AMENDMENT OF SOLICITATION/MODIFICATION OF CONTRACT			1. CONTRACT ID CODE	PAGE OF PAGES
2. AMENDMENT/MODIFICATION NO. 0002	3. EFFECTIVE DATE 16-Dec-2008	4. REQUISITION/PURCHASE REQ. NO.		5. PROJECT NO.(If applicable) 1 4

14. DESCRIPTION OF AMENDMENT/MODIFICATION (Organized by UCF section headings, including solicitation/contract subject matter where feasible.) THE PURPOSE OF THIS AMENDMENT TO SOLICITATION W917PM-09-R-0012 IS TO ANSWER QUESTIONS SUBMITTED BY THE OFFEROR AND TO INCORPORATE A SITE UTILITY PLAN AS AN ATTACHMENT.				
Except as provided herein, all terms and conditions of the document referenced in Item 9A or 10A, as heretofore changed, remains unchanged and in full force and effect.				
15A. NAME AND TITLE OF SIGNER (Type or print)		16A. NAME AND TITLE OF CONTRACTING OFFICER (Type or print)		
		TEL:	EMAIL:	
15B. CONTRACTOR/OFFEROR _____ (Signature of person authorized to sign)	15C. DATE SIGNED	16B. UNITED STATES OF AMERICA BY _____ (Signature of Contracting Officer)		16C. DATE SIGNED 17-Dec-2008

QUESTIONS & ANSWERS RFI #1

Questions & Answers for Solicitation W917PM-09-R-0010, TMC, Herat

SHEET REFERENCE NUMBER: **A - 2**
SHEET 1 OF 1

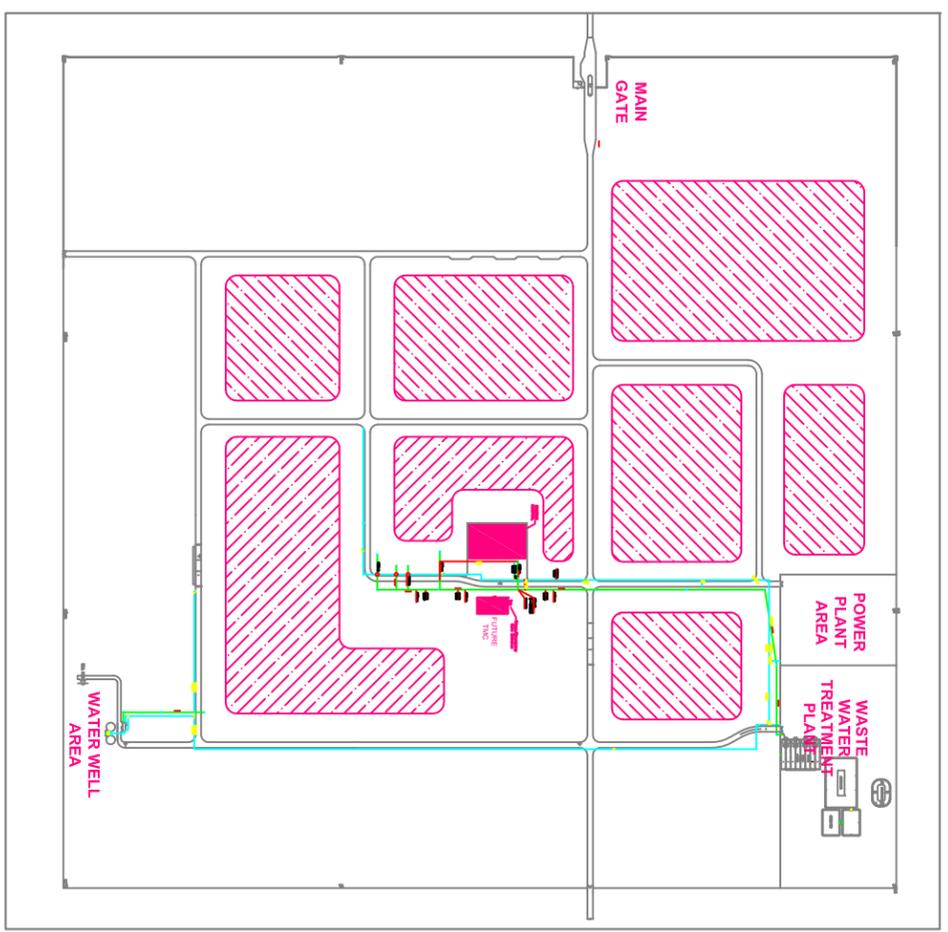
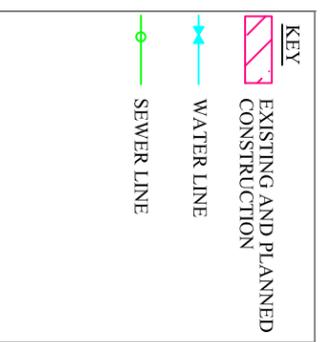
5. Shall the water needed for the TMC be connected to the existing well house or the existing water network and the pressure adjusted at the TMC to prevent water hammer.

13. Will existing utility drawings be provided?
 - Existing utility drawings will be given to the winning bidder after award of contract. For the purpose of bid preparation, the contractor shall include the cost of increased power capacity as an option item (see Line Item 0006 of Section 00010) in the cost proposal. Additionally,

- Connect to the existing water network. Attachment A-2 shows location of the buried electric, sewer, and water lines in proximity to the TMC site. Contractor shall design the system to achieve needed water pressure within the building while preventing water hammer.

drawing sheet A-2 (included in this amendment) provides information regarding location of the TMC site in comparison to the WWTP and Power Plant.
